SUPPLIER DISPOSITION REQUEST (SDR)

2. SDR No. 3801-006

<p>4. Supplier Name, Address, Telephone, Fax</p> <p>Metalex Manufacturing Inc. 5750 Cornell Road (513) 489-0507 phone (513) 489-1020 fax</p>	<p>5. Purchase Order No. <u>5A06990</u></p> <p>6. Related Documents</p> <p>6.1 ANL drawing L143-110700 Rev.7 Date _____</p>
--	--

PROJECT: STRONGBACK PROCESS
 PROJECT MGR: R. SCHULERMANN DATE: 03NOV05
 CHECKED BY: R. SCHULERMANN DATE: 03NOV05
 SCALE: FULL INCH X METRIC
 DRAWING No. MXP1143-110700-03
 SHEET 1 of 2 JOB 3801
 AutoCAD Release 14

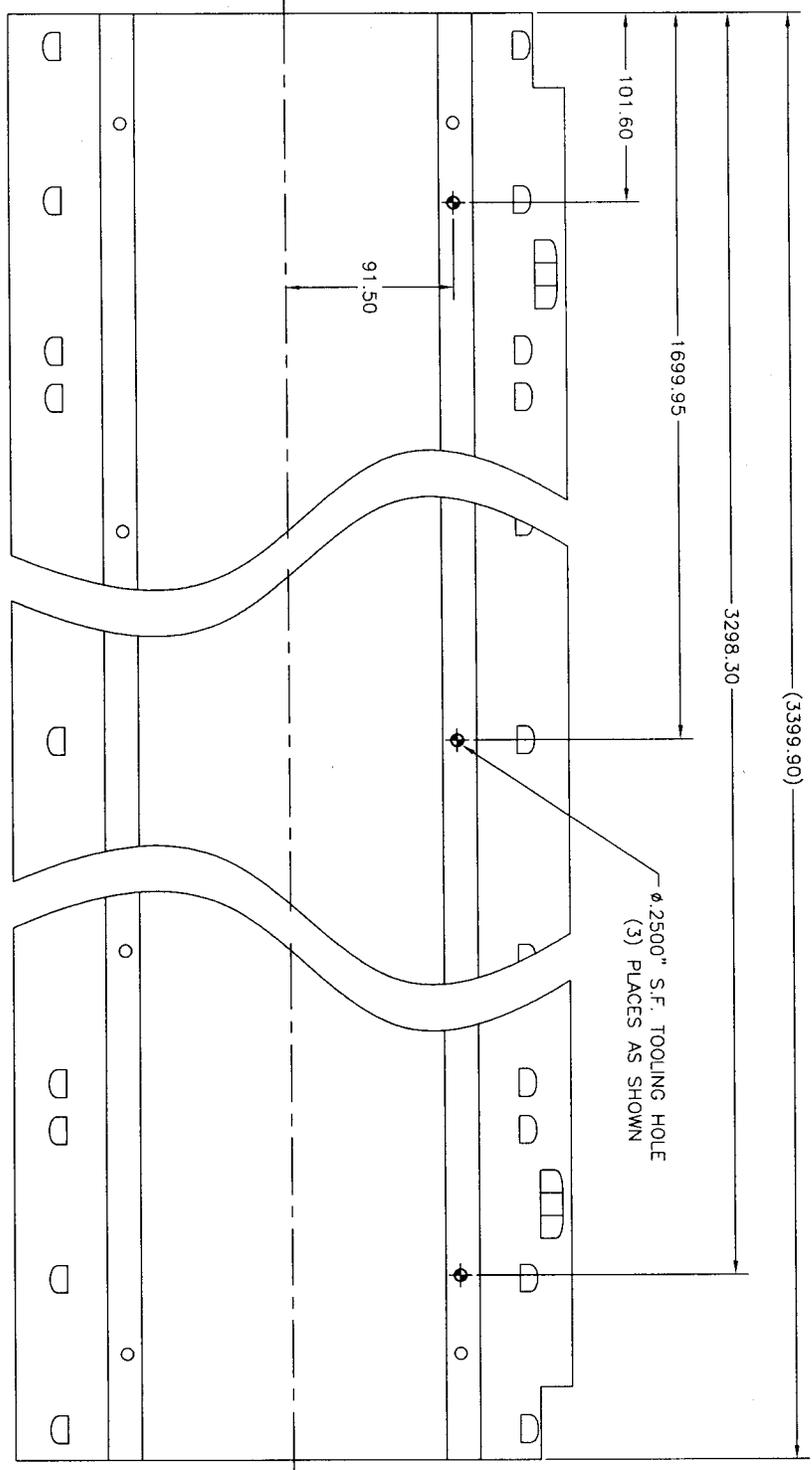
7. Qty.	8. Describe Nonconforming Condition	9. Identify Requirement	10. Cause & Corrective Action
	<p>1)</p> <p>Along with this form, Metalex has attached a sketch named MXPL143-110700-03. This sketch outlines some additional "for manufacturing process only" holes that Metalex is requesting permission to add to the production Stongback details.</p> <p>These three (3) .2500" diameter tooling holes located as shown will allow ease of manufacturing and inspection of the critical overall length of this detail.</p>	<p>Metalex requests direction and approval from ANL on this item.</p>

These three (3) .2500" diameter tooling holes located as shown will allow ease of manufacturing and inspection of the critical overall length of this detail.

17. ANL Disposition and Remarks: Acceptable.
